## **Clean Energy Council submission to the Australian Energy Market Operator Draft Determination: Amendment of the Market Ancillary Service Specification - DER and general consultation**

The Clean Energy Council (CEC) welcomes the opportunity to provide feedback on the Australian Energy Market Operator (AEMO) Draft Determination on amendment of the Market Ancillary Service Specification (MASS) for distributed energy resources (DER).

**Figure 4.1 — Example frequency response for a decrease in frequency for an inverter that has a reduced output**

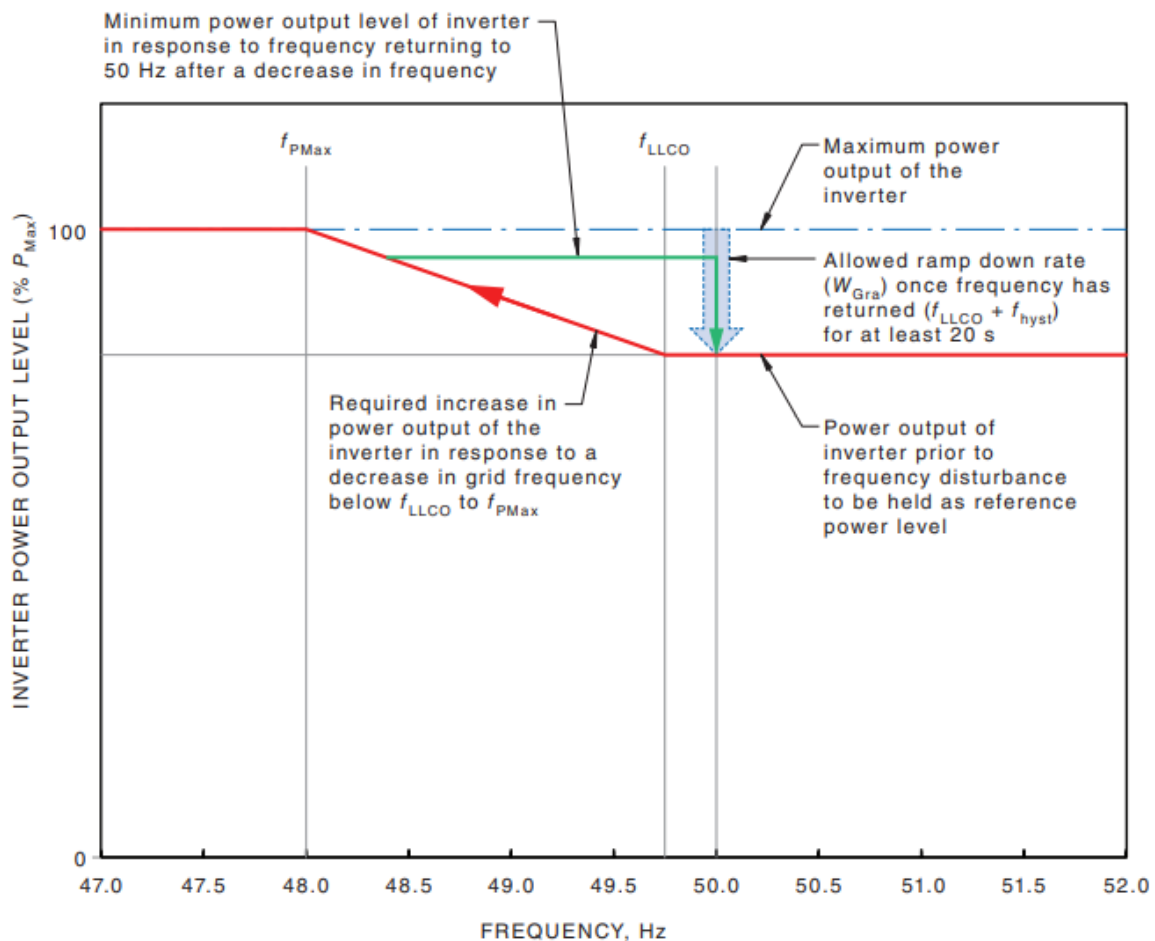
Thus, when frequency falls below the continuous operation range, inverters are required to increase their output if it was previously curtailed by volt-var and/or volt-watt response modes as illustrated, below.

The test procedure described in clause J.3.4, raises the voltage into the volt-watt region and then reduces frequency down below 48Hz to confirm this behaviour. This is a mandatory response. Delivering an FCAS response in advance of this would not necessarily conflict with AS/NZS 4777.2:2020.
